**HDC-2022-00011**

**Address: 1553 W. Turner Street**

**HDC-2022-00017**

**Address: 210 N. Howard Street**

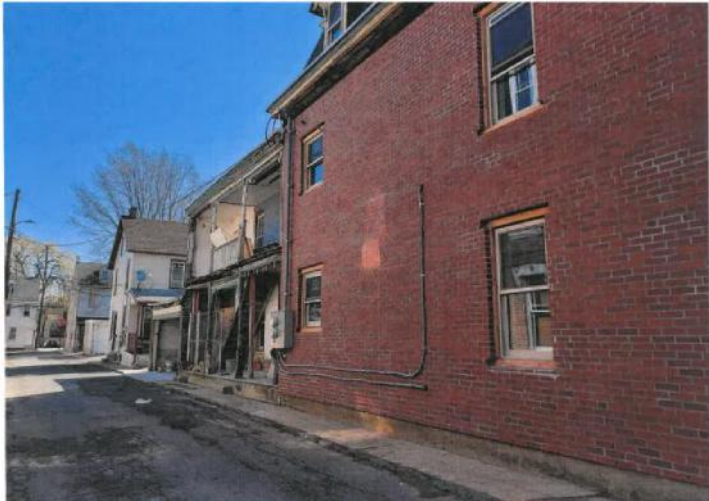
The proposed replacement steps do not meet the Guidelines as an appropriate replacement. The proposed design is a single-run stair with no side walls. This design does not resemble the existing stair, which has two runs and an intermediate landing, side walls, end posts, and bullnose treads. An appropriate replacement should match the existing feature as closely as possible. The use of concrete is appropriate as an in-kind replacement material. It is recommended that the applicant clarify if new handrails are part of this scope of work.

AJ asked to retain side walls and insert new steps between them; also asked extent of included extending concrete to the sidewalk by removing the landing and step extension at the bottom. If the sidewalls cannot be reused then the new must be rebuilt to match the existing.

GL recalled the historic character of the sidewalls and newel post of the existing and the new should replicate, retaining the plinth and rebuilding from that point up to match existing detailing, profile and dimension.

GL stated railing should be replaced with new that is code compliant using a square picket shape.

HARB chair Dave Huber made a motion to approve with conditions, the application presented on 04/04/2022 for replacement of concrete stairs at 334 N. 9<sup>th</sup> Street with the following conditions agreed to by the applicant: including retain the sidewalls and rebuild stairs between, or rebuild sidewalls to replicate the existing in dimension and profile. replacement stairs to have bullnose edge detail to match existing and remove lower stair and landing extension and install new square stock baluster handrail to meet code.
